Re: Project Name
4910 Union Way Dr. NE
30-Day Temporary Certificate of Occupancy
Transportation Development Final Inspection
Engineer's/Architect's Stamp dated 2-24-20 (F16D015A)
Certification dated 12-29-20

FFCU OFFICE BUILDING DESIGN BUILD
UNION WAY ROAD NE
ALBUQUERQUE, NM 87107

**Re: Transportation Final Certificate of Occupancy
First Financial Credit Union
4910 Union Way, NE**

AS101
OF

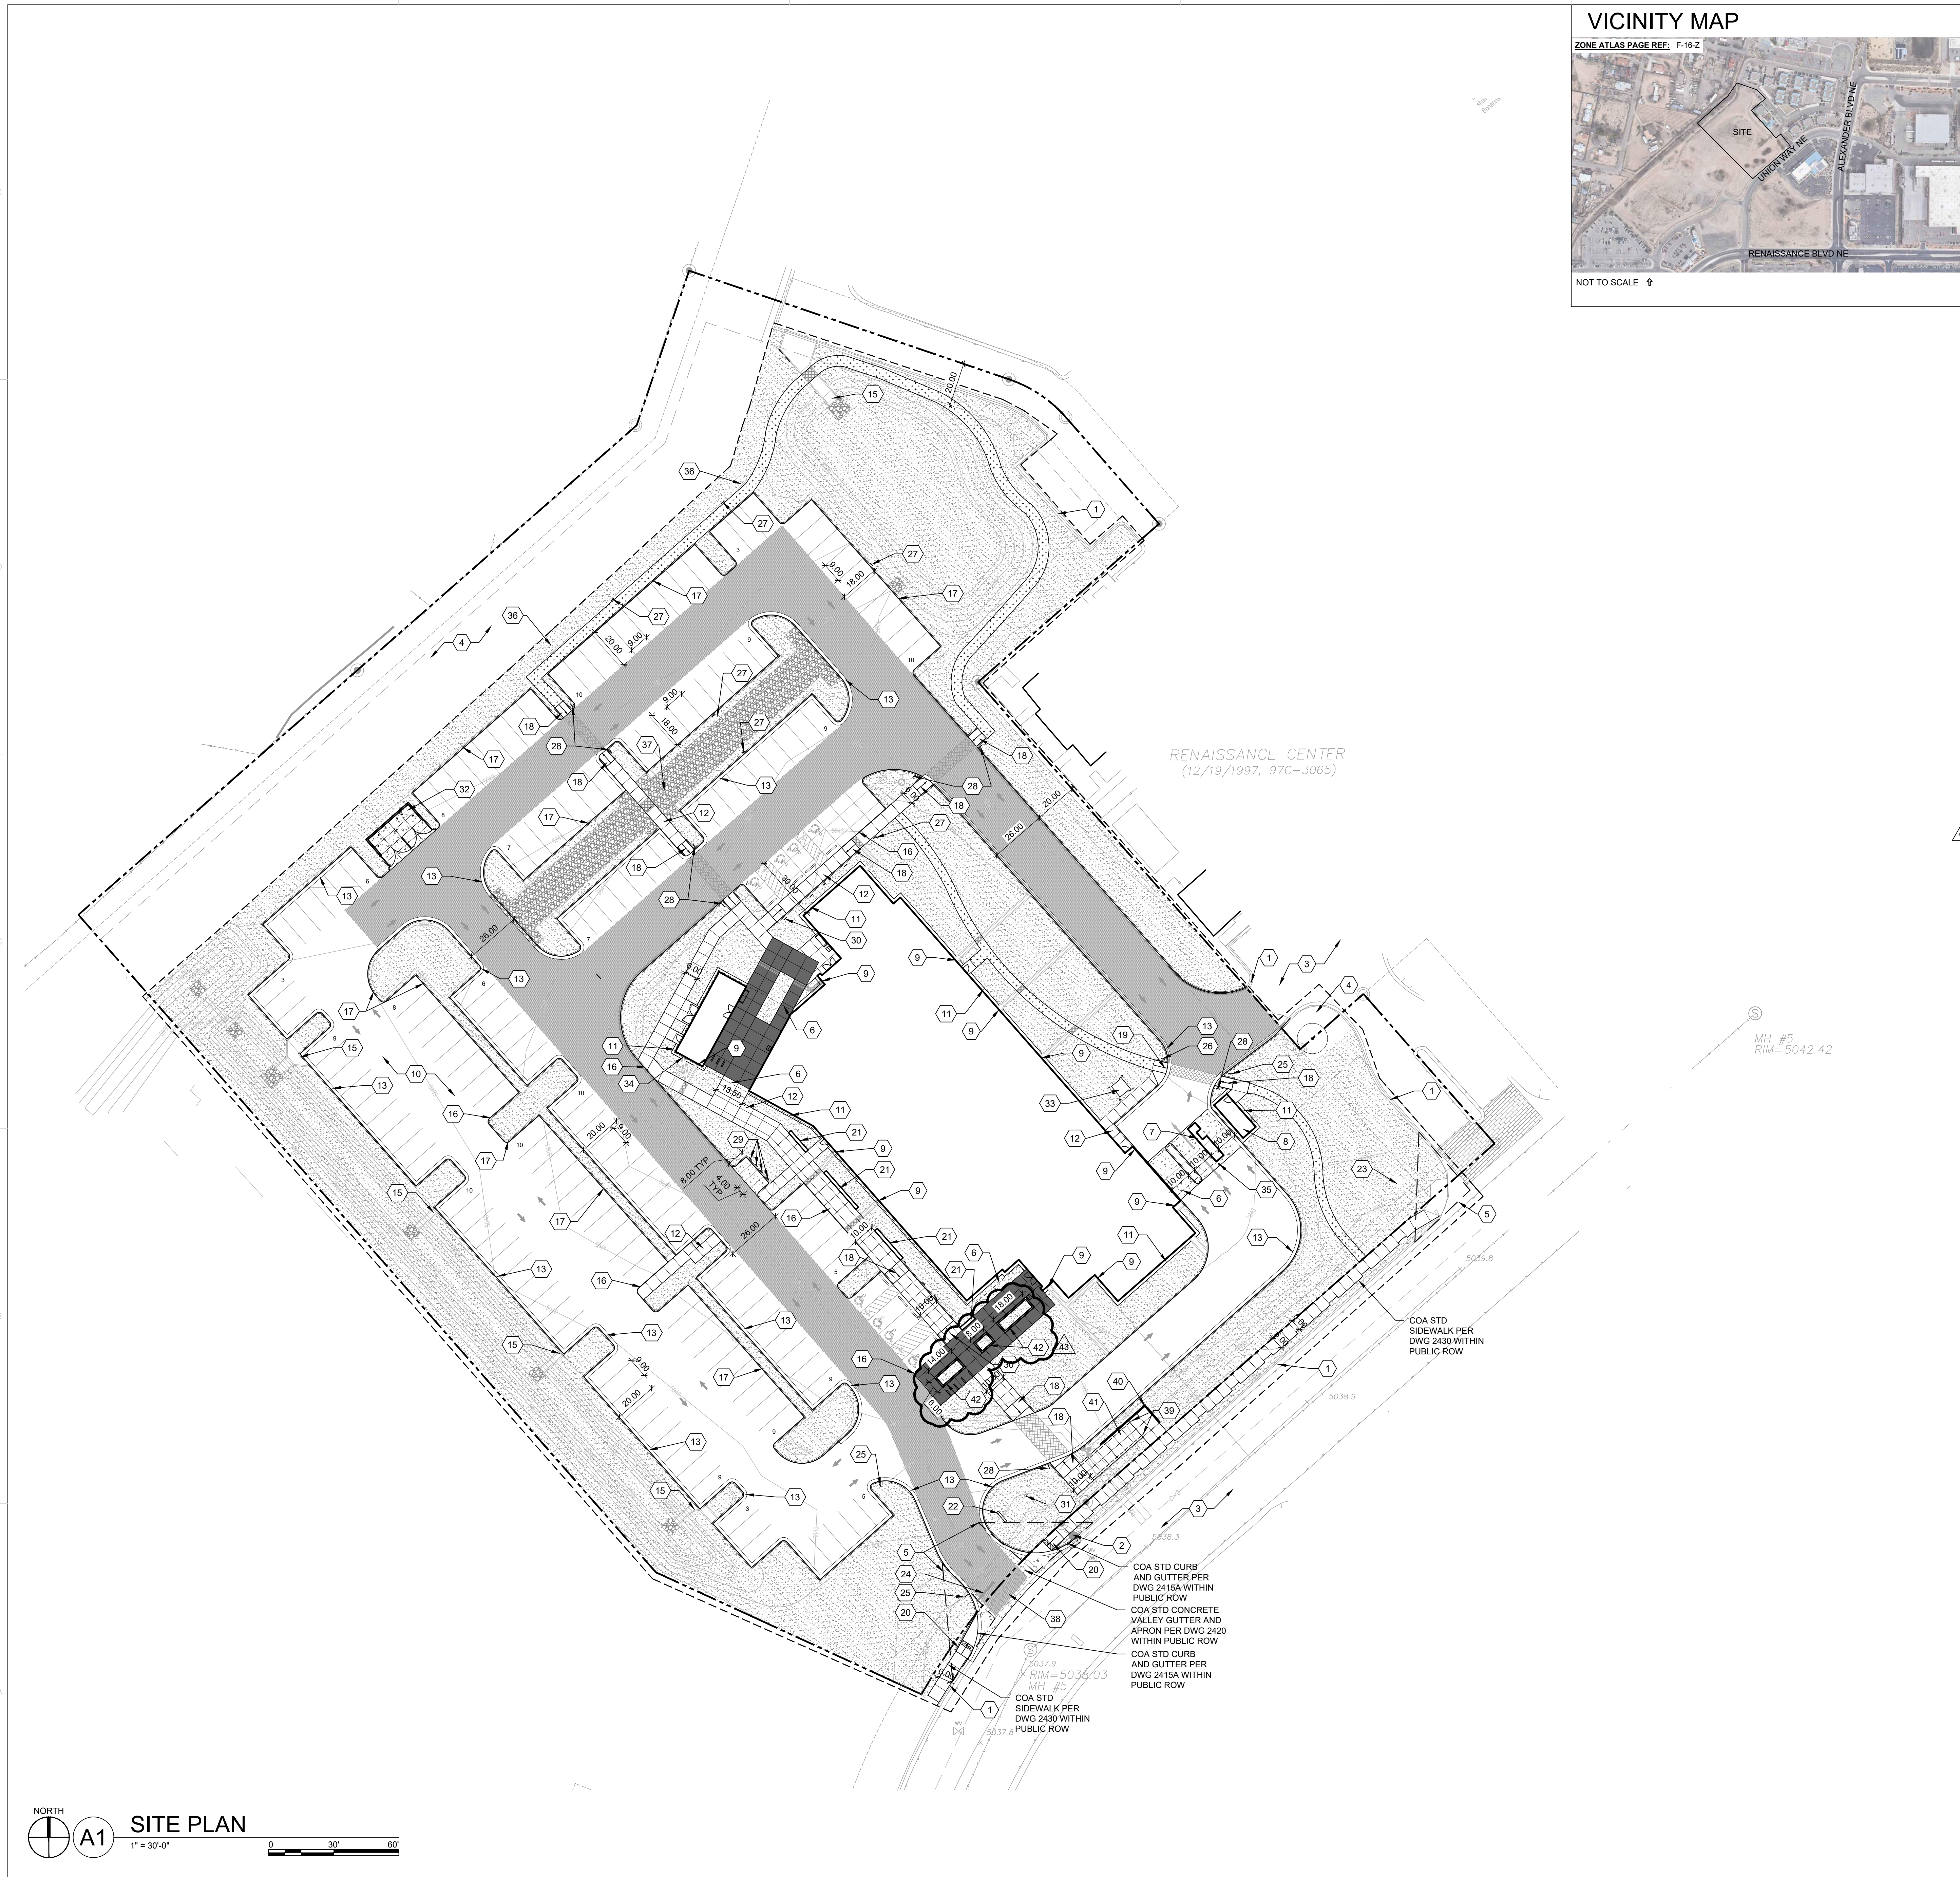
- Please install drive thru ATM.
- Remove construction debris, equipment and trash container from site.
